Executive Manager,  
Environment & Transportation Department,  
Block 2 Floor 6, Civic Offices,  
Dublin City Council,  
Civic Offices,  
Wood Quay, D8

## FitzWilliam Cycle Route Consultation - October 2018

### 3.3 No Raised Table at FitzWilliam Lane

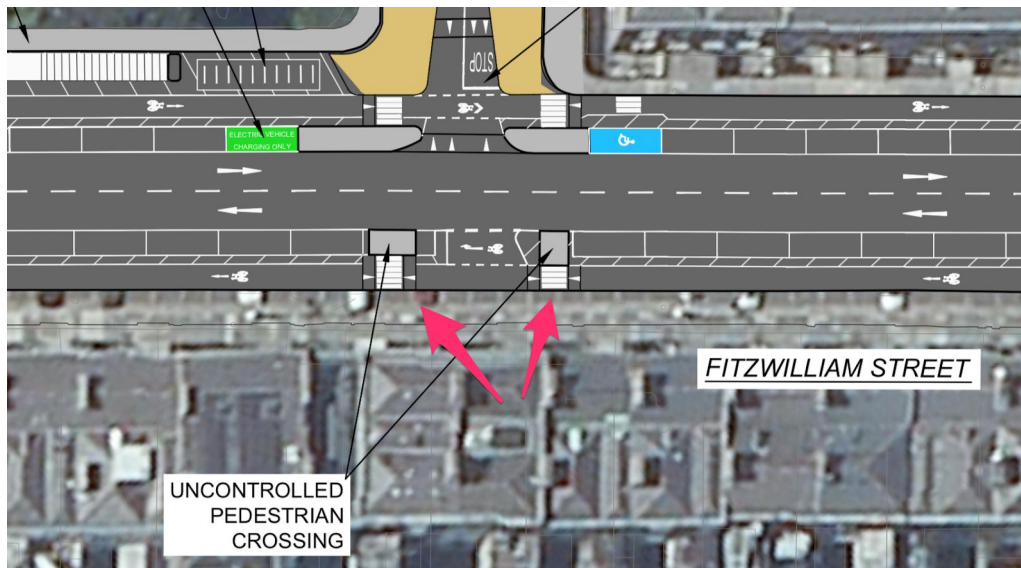
There is no raised table for vehicles as they cross from FitzWilliam Street into FitzWilliam Lane. FitzWilliam lane might appear as just a tiny bin lane however, there are surprisingly large volumes of traffic entering Fitzwilliam Lane. FitzWilliam Lane is the only access to many surface car parking areas and a 6-story private car parking building. It is also a through one-way road.

The current design suffers from poor legibility. It isn't clear that vehicles crossing the cycle lane are required, under the rules of the road, to yield to cyclists. Adding a raised table here, like the other crossing points, will improve the legibility of the road inline with the principles of sustainable safety. Research from London by TfL shows that adding raised crossings like this reduces turning collisions with cyclists by 20%<sup>1</sup>.

The image below is of the Baggot Street junction. All of the corner islands are too small.

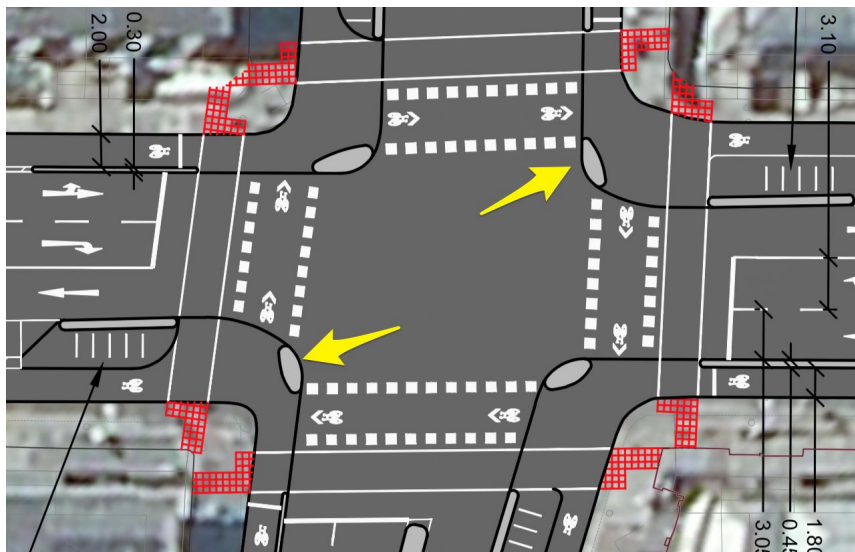
The size of some of corner islands are too small to achieve the benefits of a protected corner island design. One of the key parts of the this design is that a turning vehicle and a straight moving cyclist meet at a right angle. This provides good line-of-sight between the cyclist and the driver.

There are two ways that this design could be altered to increase the size of these corner islands so that motor traffic and cyclists meet at an appropriate angle. Turning lanes for motor traffic could be removed. This allows for a large buffer space and increases the size of the turn for motor vehicles. Where this is not possible the council should consider setting back the pedestrian and bike crossing from the junction. This provides more space, which can be used to increase the size of the corner islands.

### 3.7.2 Missing stop lines for cyclists

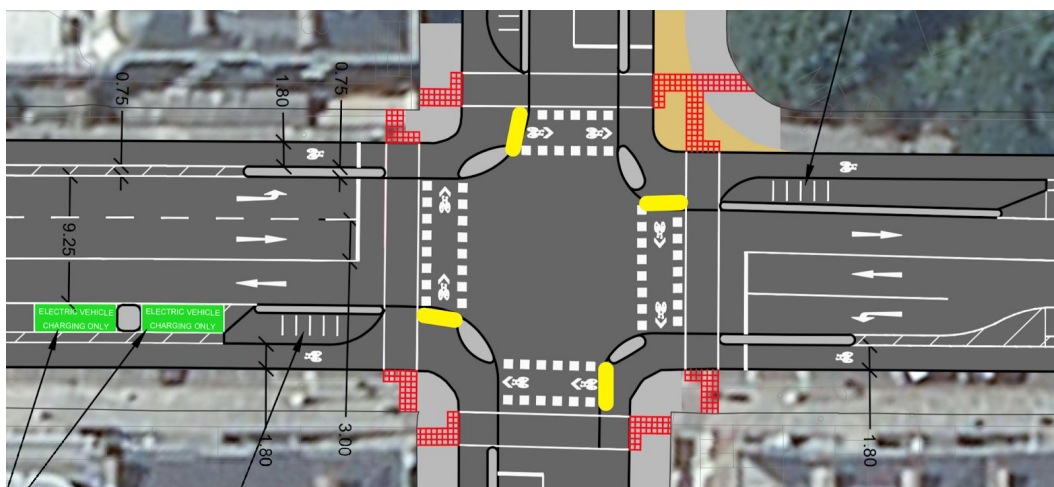
There are also missing stop lines. This gives cyclists the wrong impression that they can continue on through the junction. In the image below we have added the four missing stop lines to the junction. These stop lines are for cyclists making turns.

A key part of this design is that cyclists should have an advanced stop location ahead of the vehicle stop line. Cyclists will be in front of drivers and in clear view. This means that most cyclists will have cleared the junction ahead of any motor traffic if they are on the same green phase. This substantially reduces the likelihood of left-hook collisions.

Where a buffer space exists, there should be a pedestrian waiting location across the cycle track. In the image below this is marked in yellow. Providing an uncontrolled zebra crossing of the cycle track, with pedestrian priority, allows cyclists to move up to the advanced stop lines (section 3.7.3 above) and for shorter pedestrian crossings.
